**ADDENDUM NO. 3.0**

**REPLACEMENT OF INDUSTRIAL AVENUE BRIDGE (NO. 025030) OVER UNNAMED  
STREAM PROJECT  
Cheshire, Connecticut**

**Addendum No. 3 Issued February 23, 2024**

DRAWING NO.: STR-01

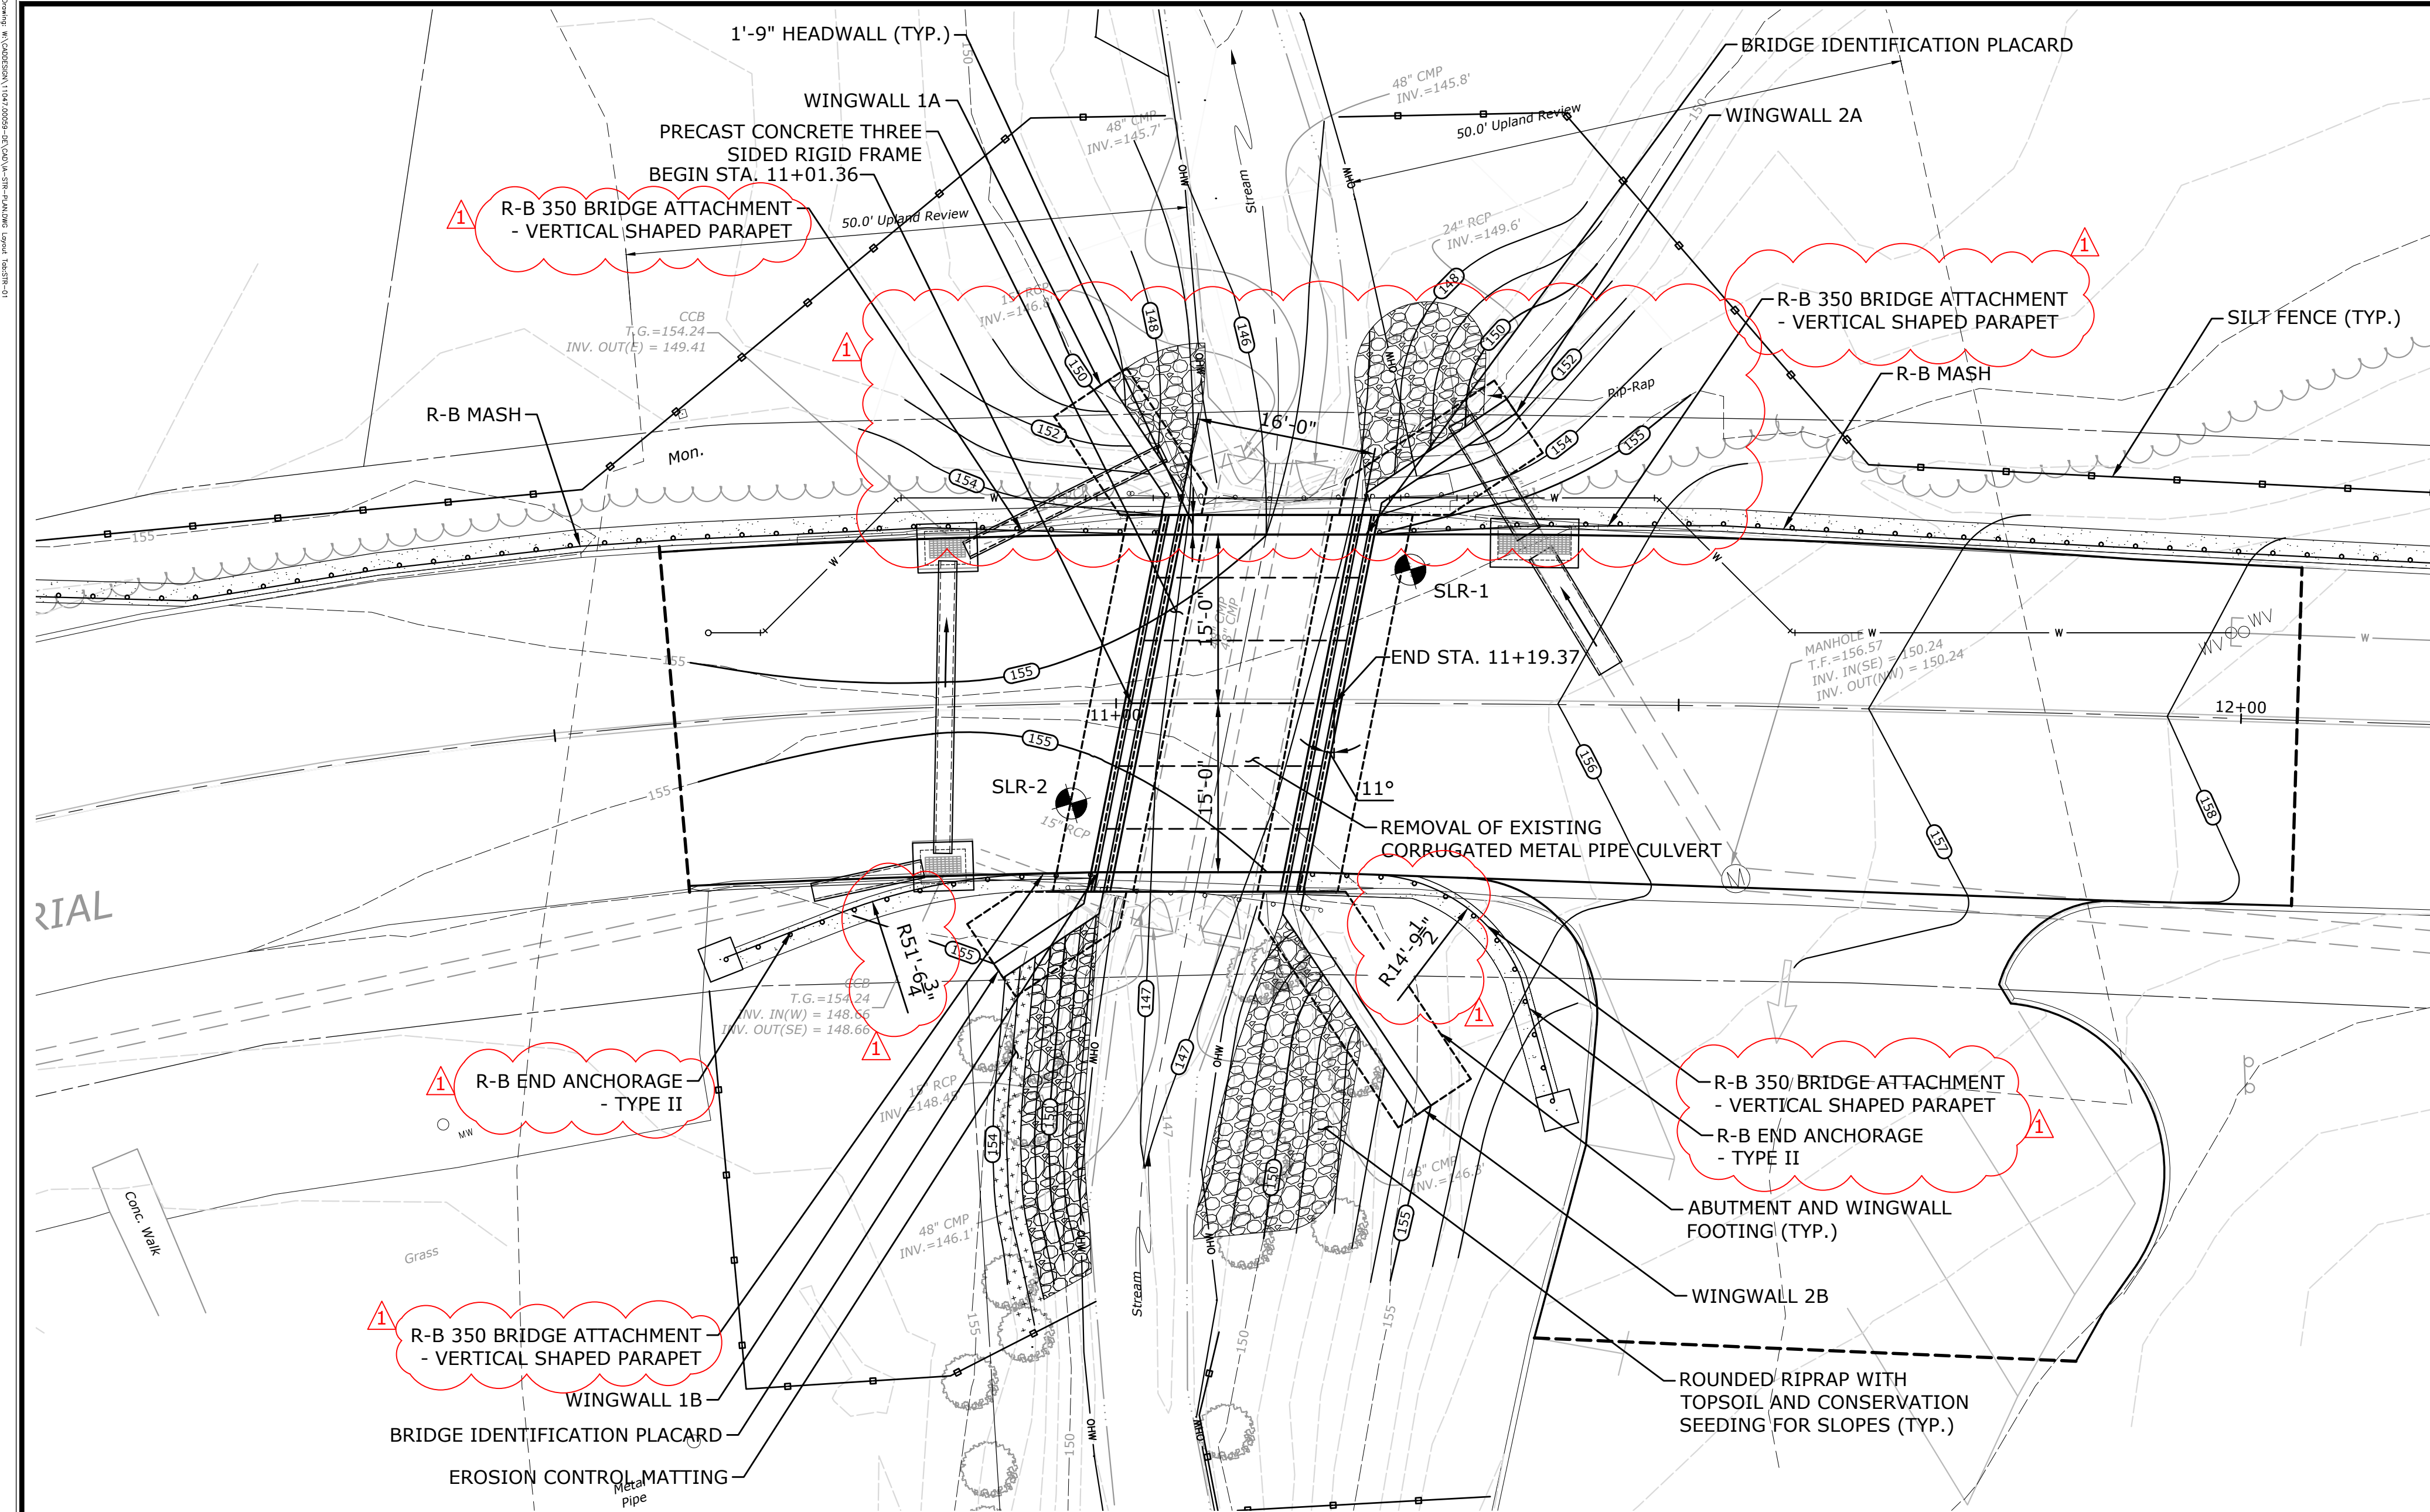
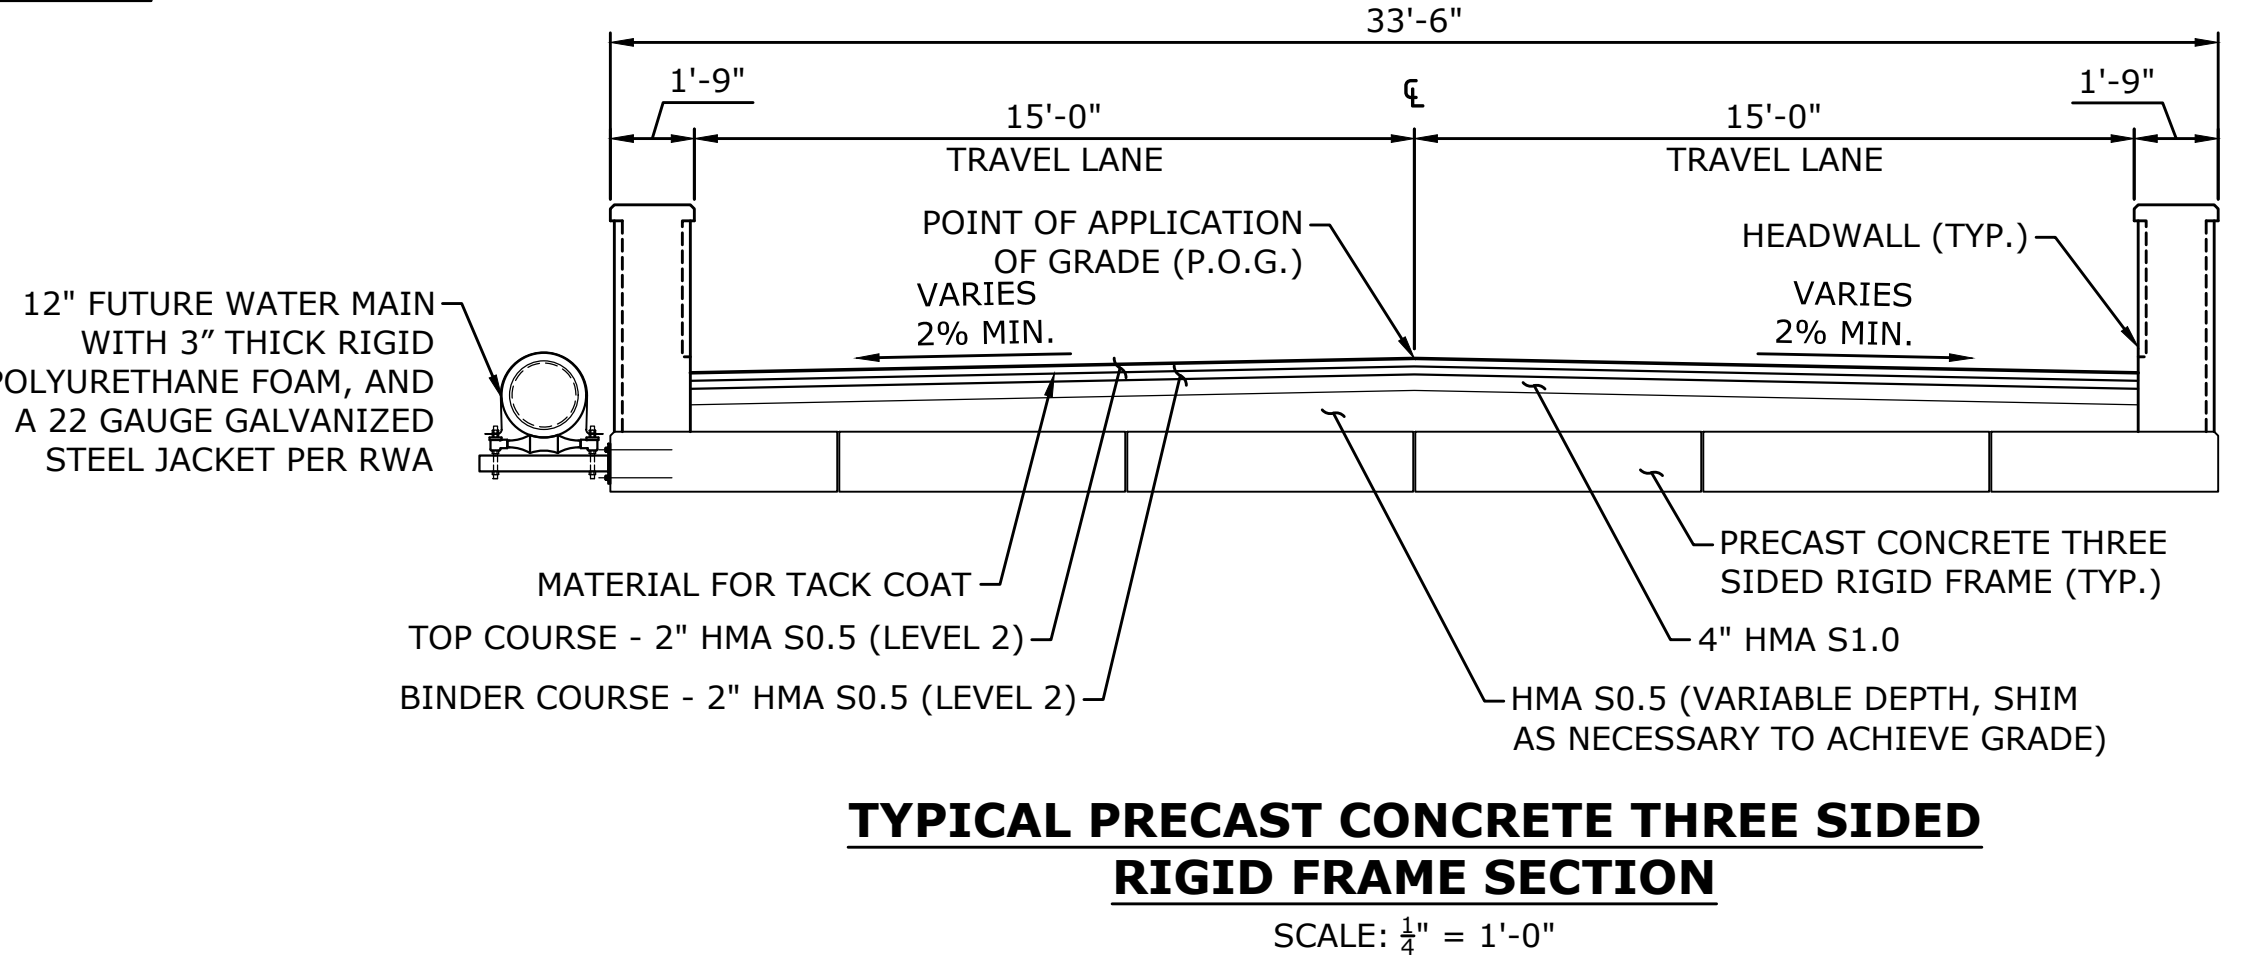
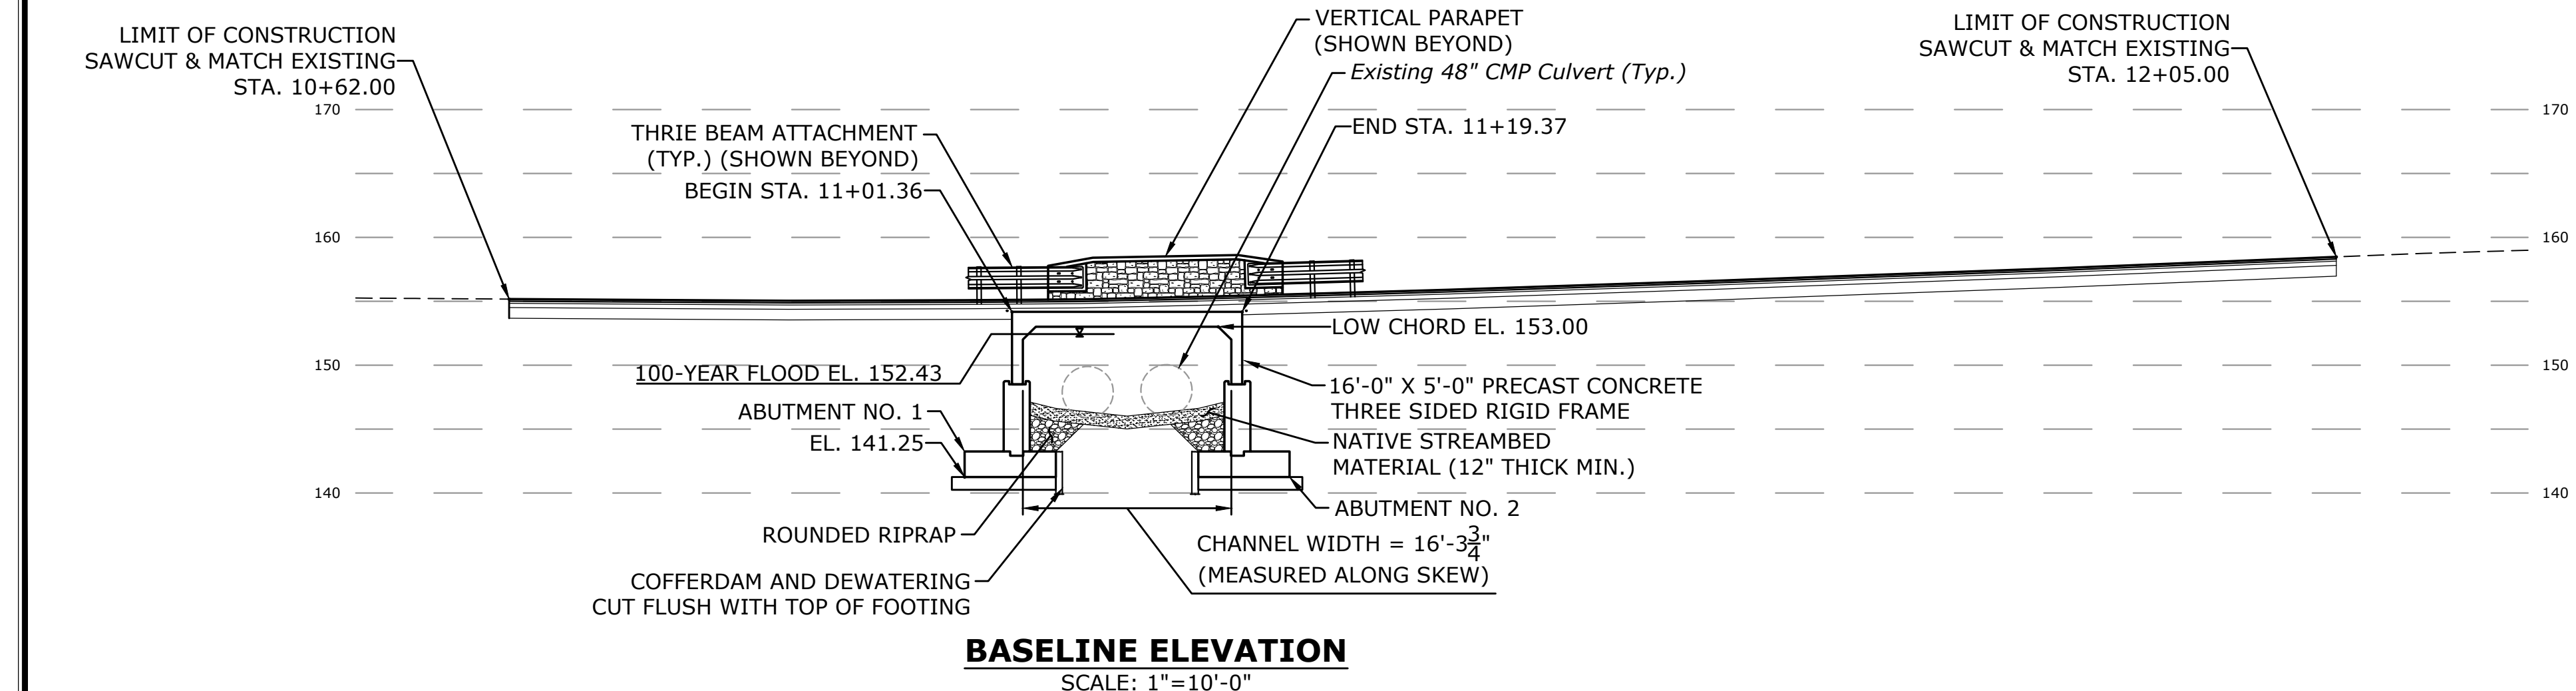
- R8. The contractor's Surety bid bond.
- Q9. The south side of the bridge has 2ea Thrie Beam Bridge attachments, these attachments are shown to have a radius. Thrie Beam Bridge attachments cannot be bent per the manufacturer and FHWA guidelines. A radius panel can only be installed at the end of the transition panel at post #10.**

- R9. See revised sheet STR-01 for updated Guiderail callouts. R-B350 Bridge Attachment with curve has been designed for and constructed in a recent project. A curve radius has been provided.
